REPORT of SURVEY for REPAIRS, &c.

on the *Iron Steamer "Ananda" (contd)*

475 ^{Don} Sketch showing borings of the outside plating. S.S. "Ananda"
Starboard Side.

Sketch showing Thickness of deck.

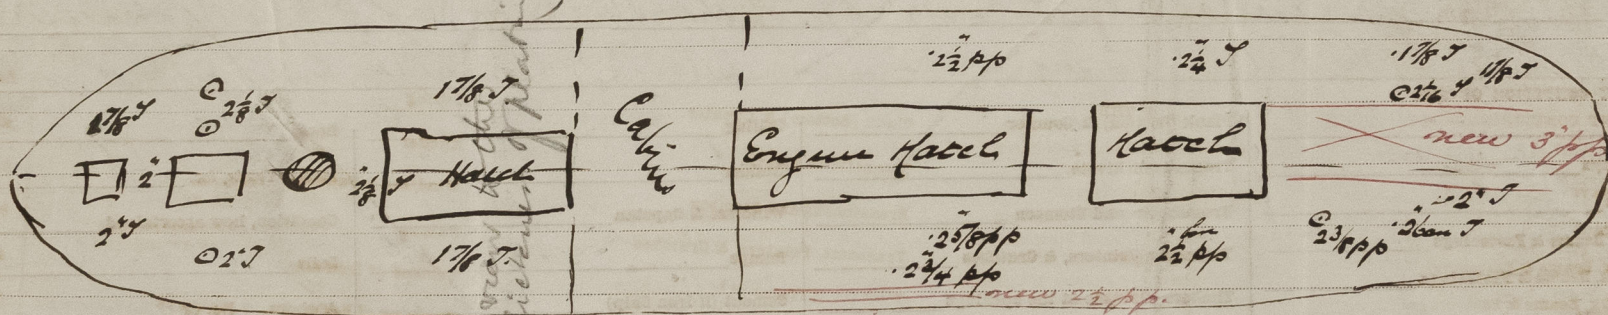
The rules required when the vessel was built $3\frac{1}{2}$ " pitch pine or 3" Oak. but $2\frac{1}{2}$ " Oak was allowed to be fitted for first entry Report. The owners have been recommended to renew or double this deck. The doubling to be at least 2" thick p.pine.
